RE: Circle K at Hwy 24 & Meridian: PCM Certification Letter

CIRCLE K AT HIGHWAY 24 & MERIDIAN ROAD
100% CONSTRUCTION DOCUMENTS

AS-BUILTS

SECTION M
NTS

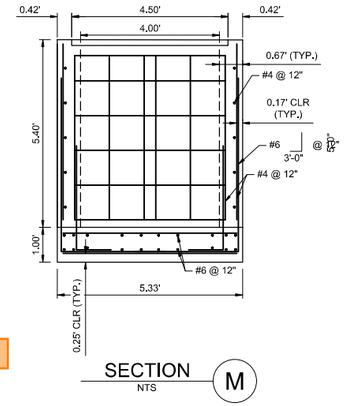
0.35 per calcs (4.25/12)

STORM DRAIN PLAN & PROFILE

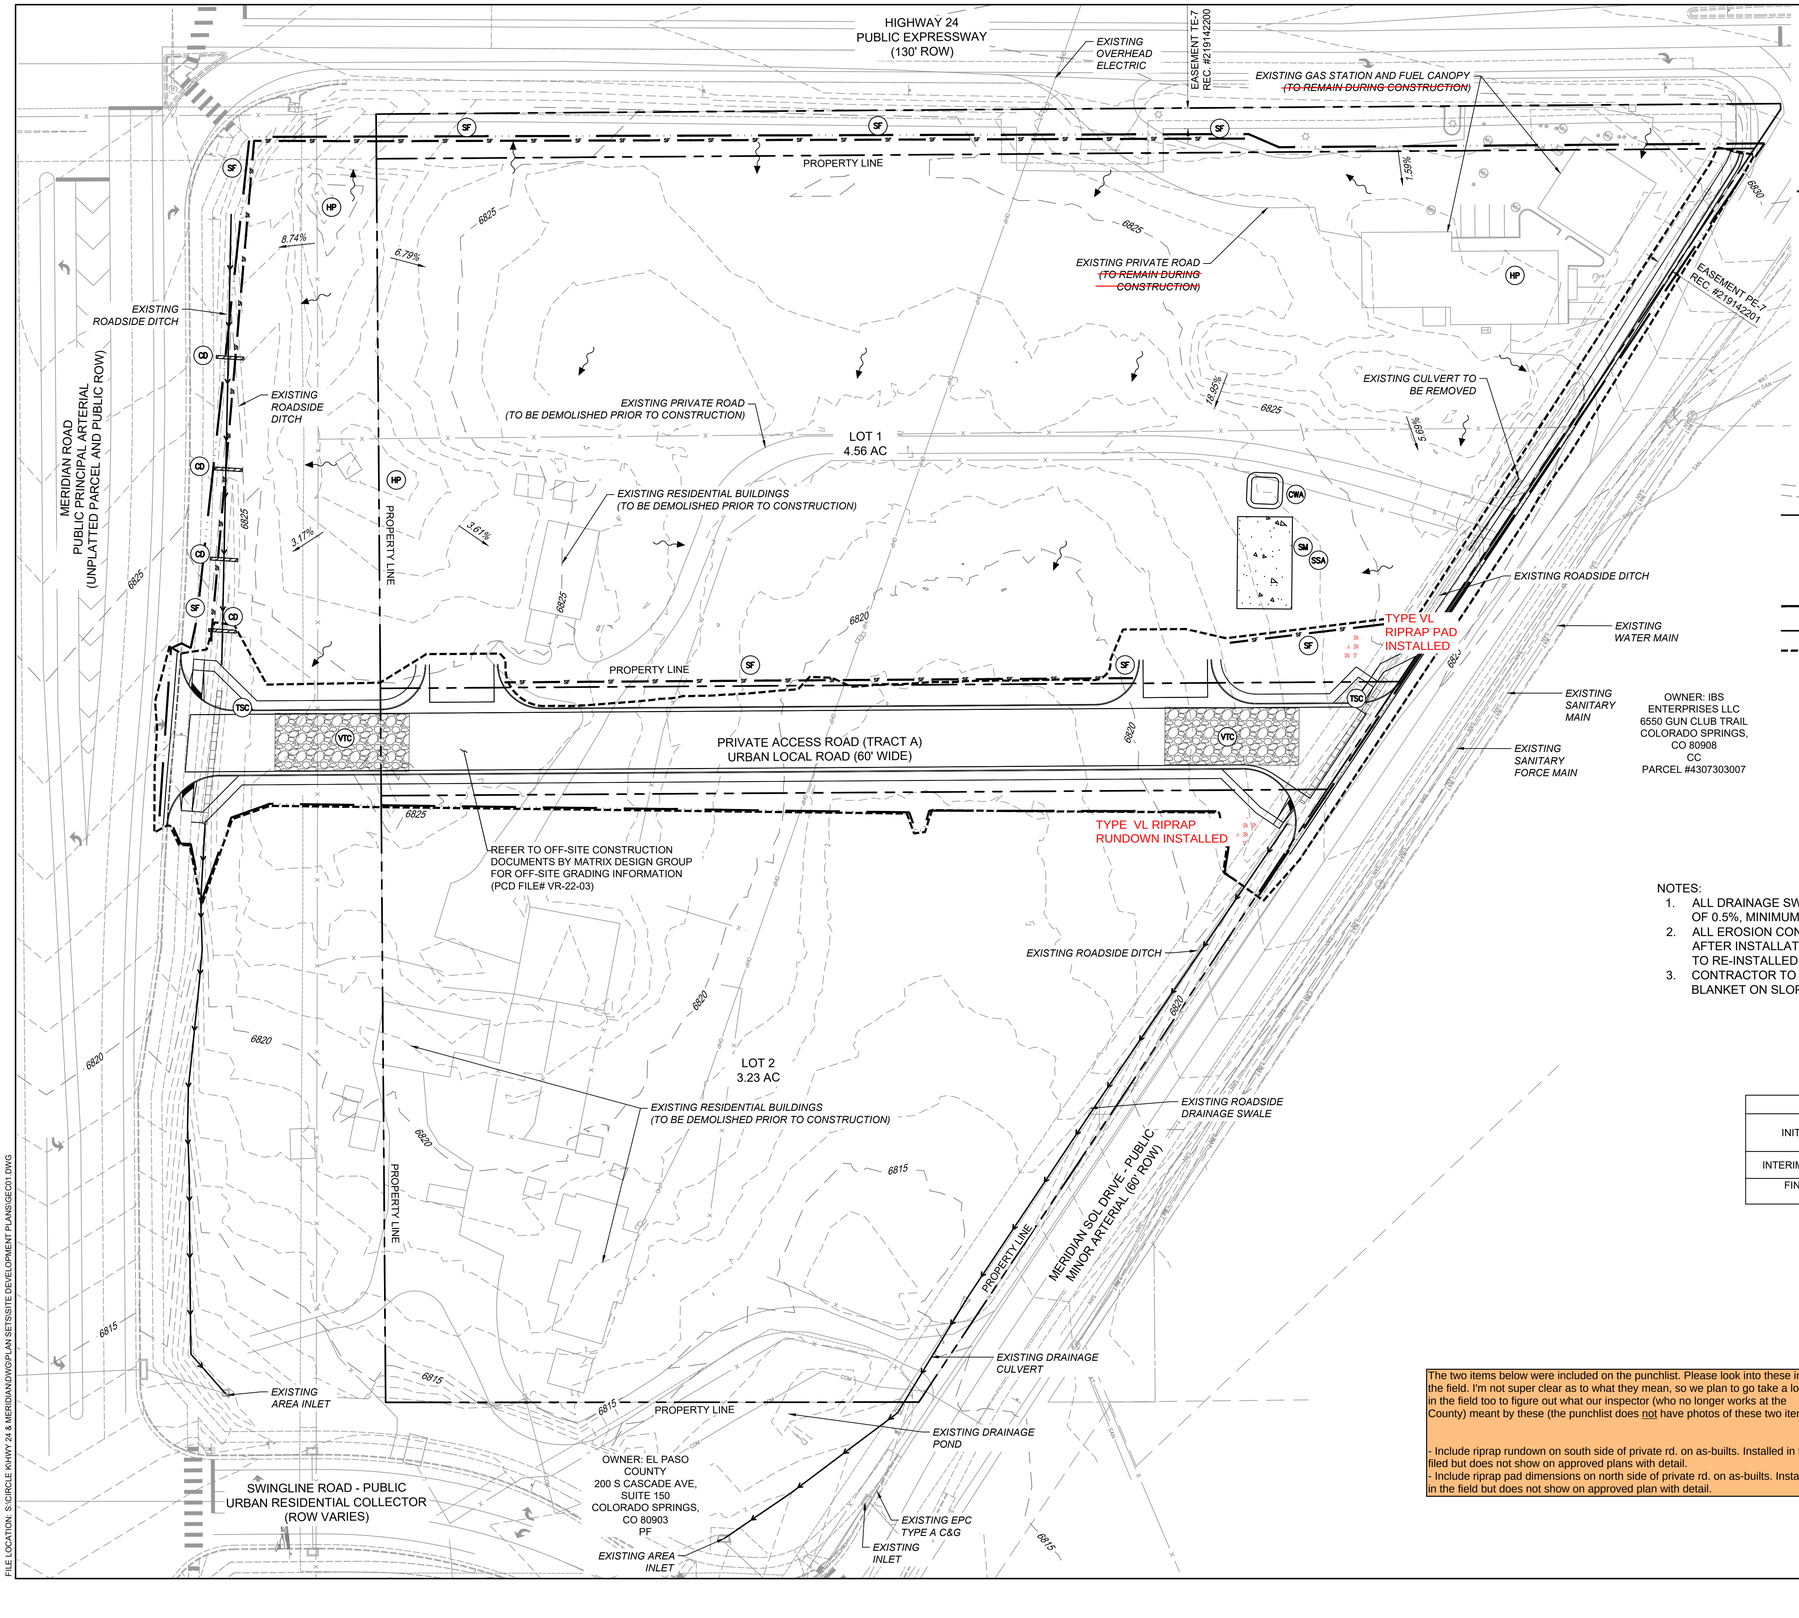
The two items below were included on the punchlist. Please look into these in the field. I'm not super clear as to what they mean, so we plan to go take a look in the field too to figure out what our inspector (who no longer works at the County) meant by these (the punchlist does not have photos of these two items).

- Include riprap rundown on south side of private rd. on as-builts. Installed in the filed but does not show on approved plans with detail.
- Include riprap pad dimensions on north side of private rd. on as-builts. Installed in the field but does not show on approved plan with detail.

INITIAL GRADING & EROSION CONTROL PLAN

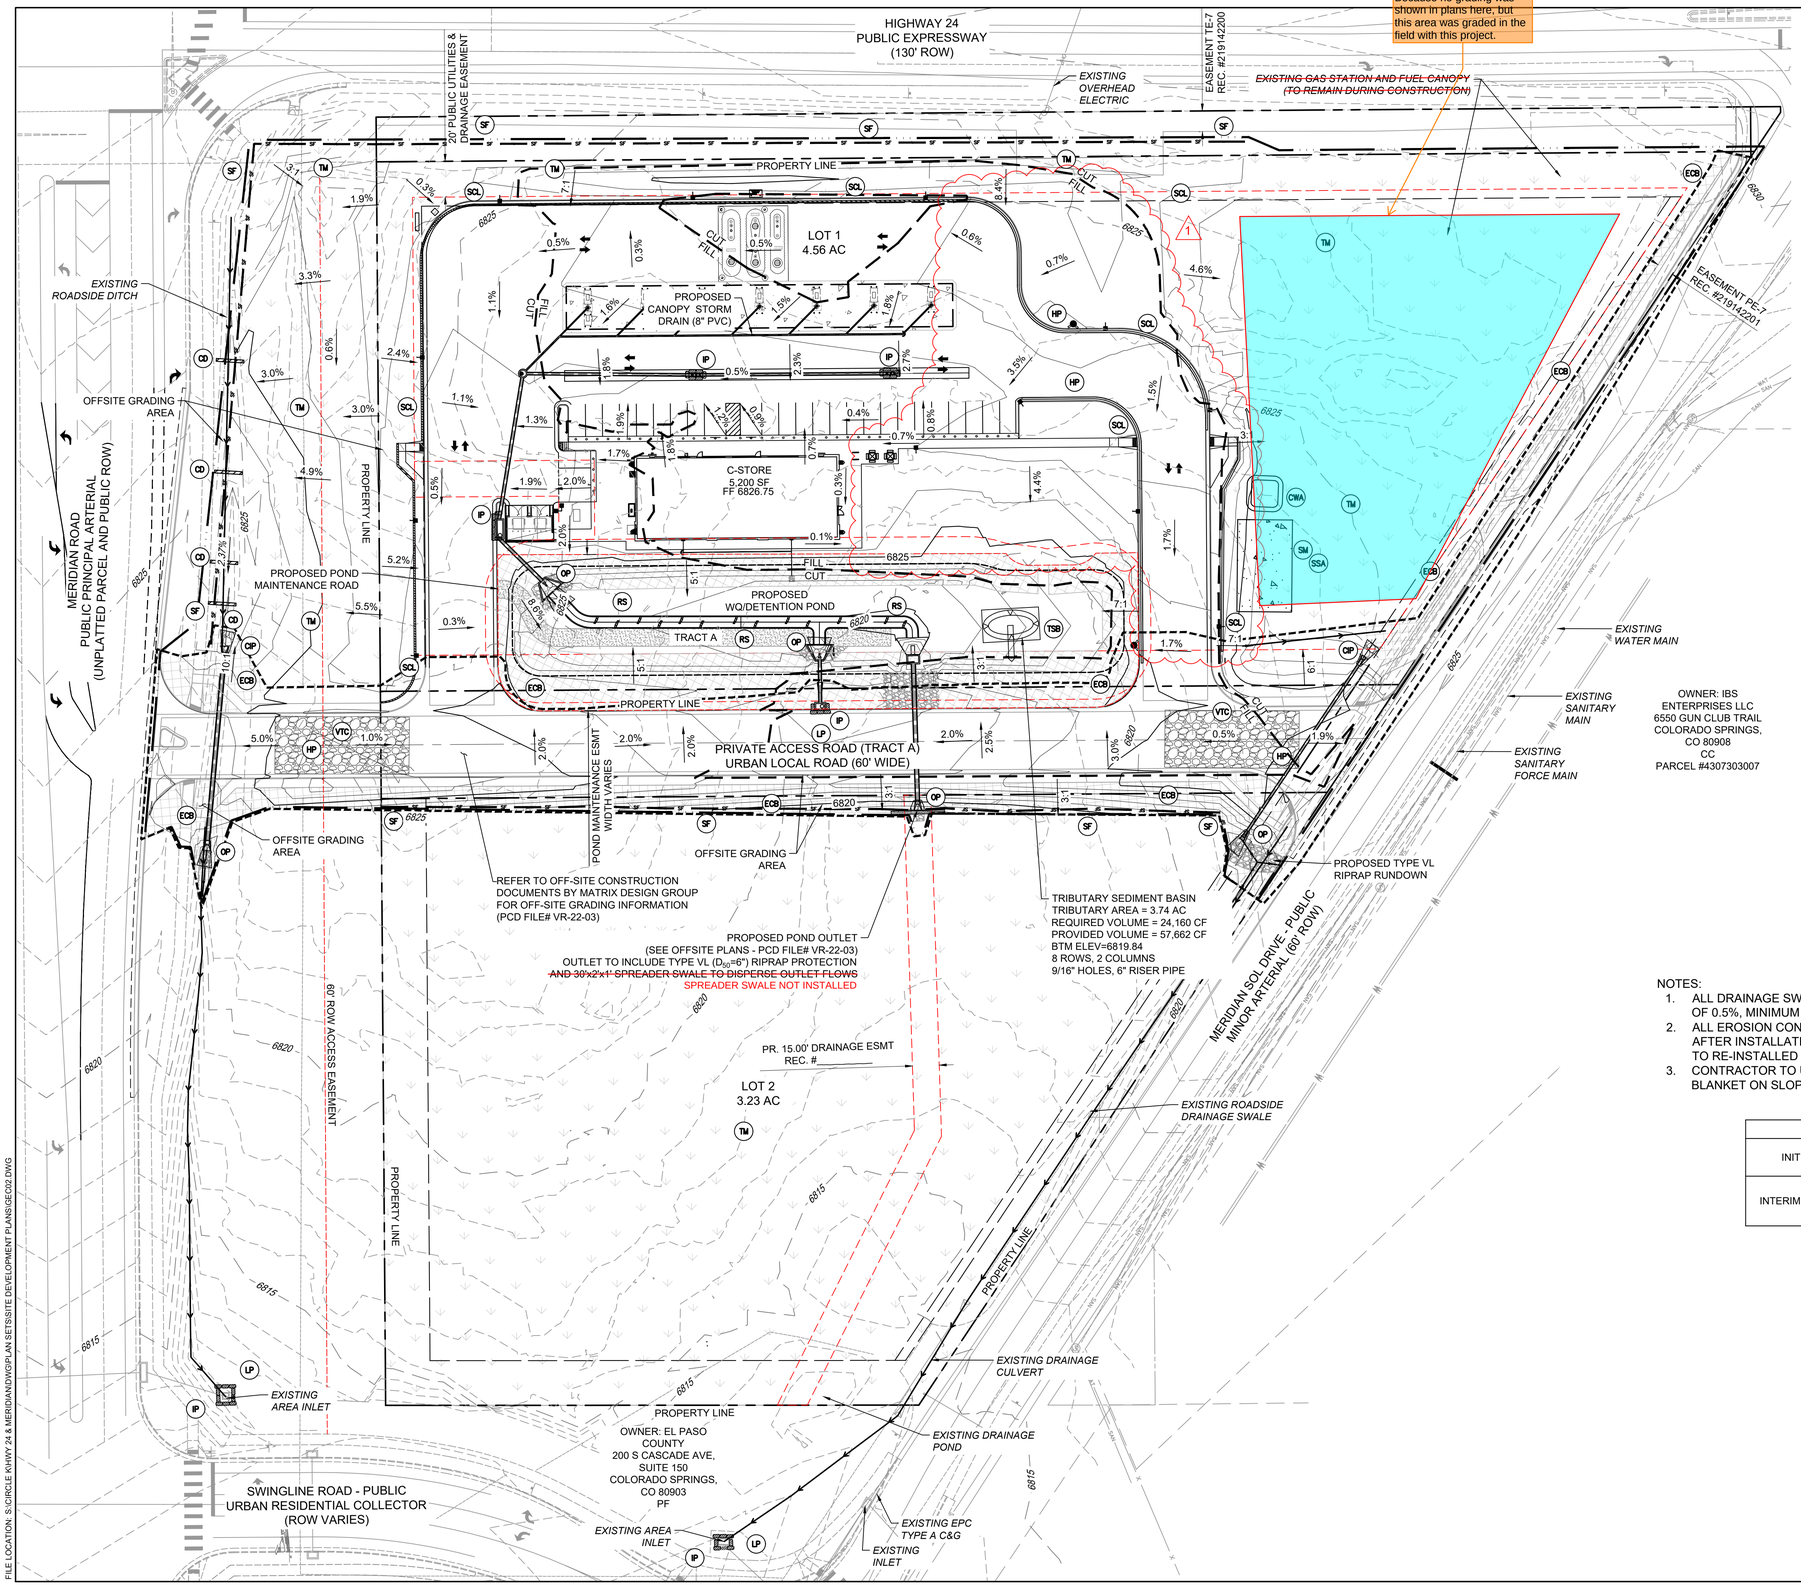
Please as-built the grading in this area and make sure the drainage doesn't differ from the original design. Because no grading was shown in plans here, but this area was graded in the field with this project.

DETENTION BASIN STAGE-STORAGE TABLE BUILDER

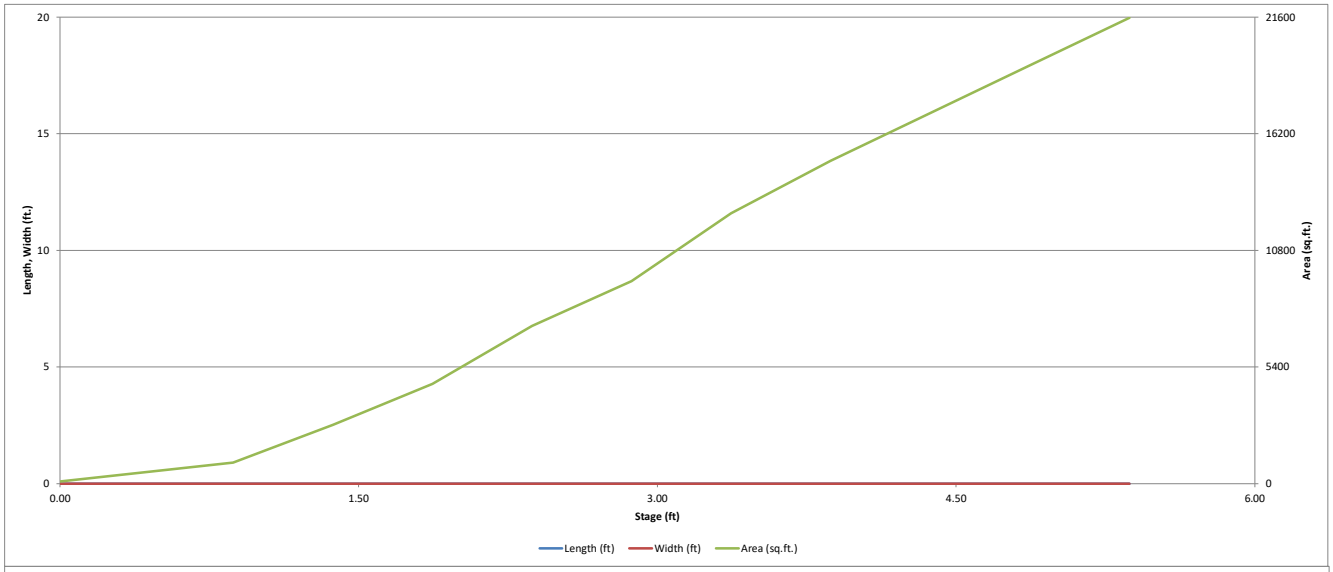
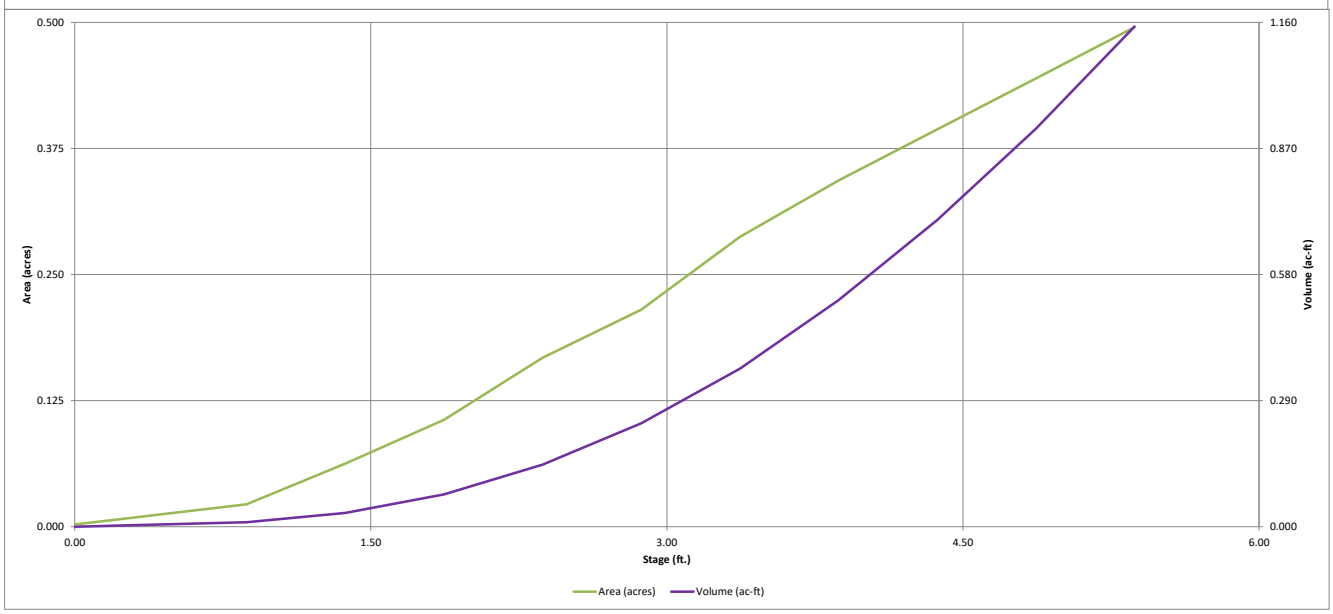
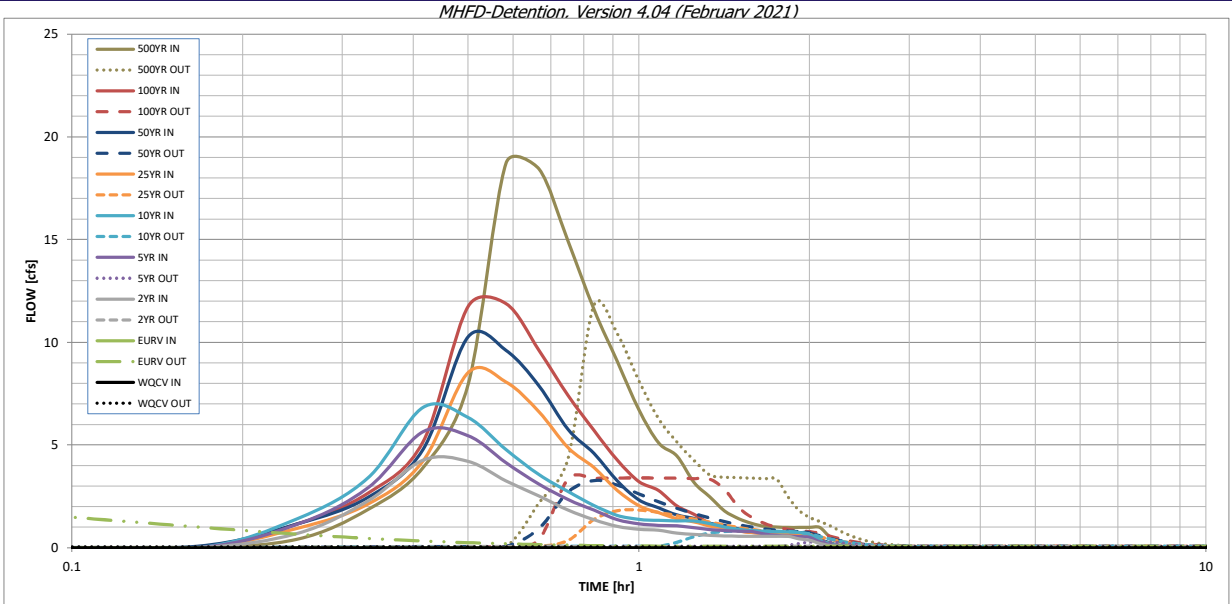
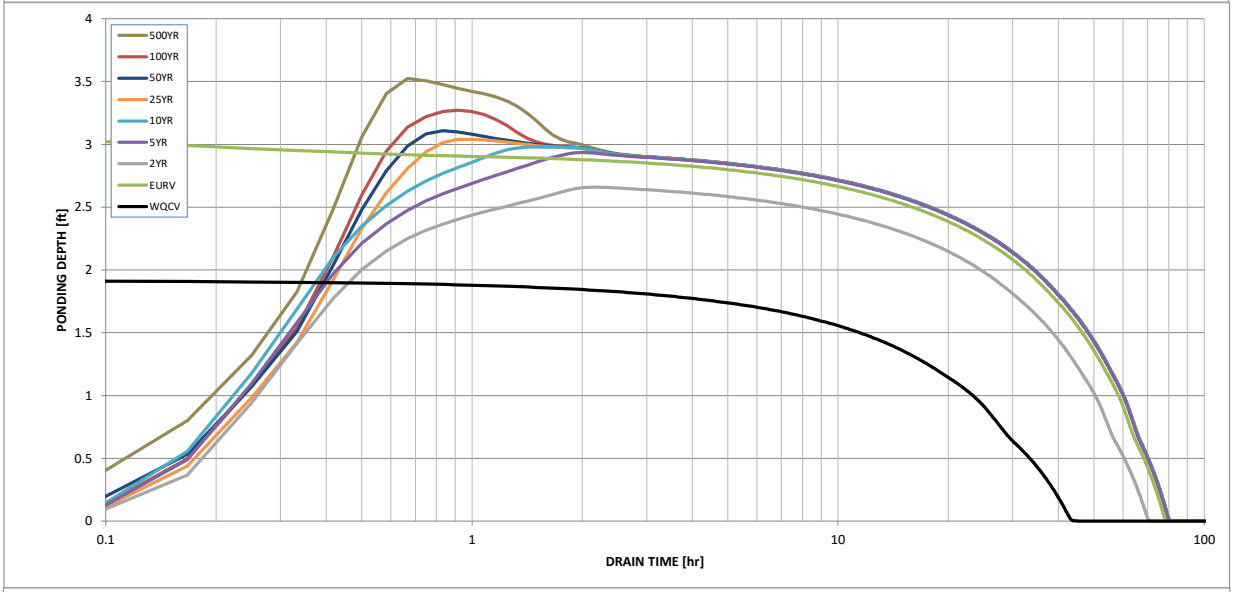
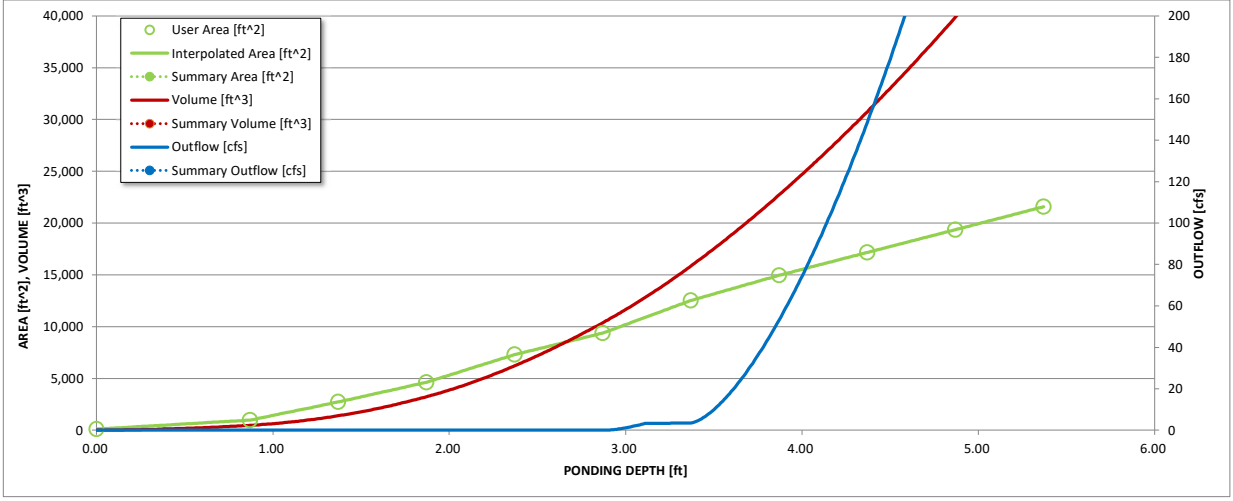
✓ = calcs match details in plans

X = calcs do not match details in plans
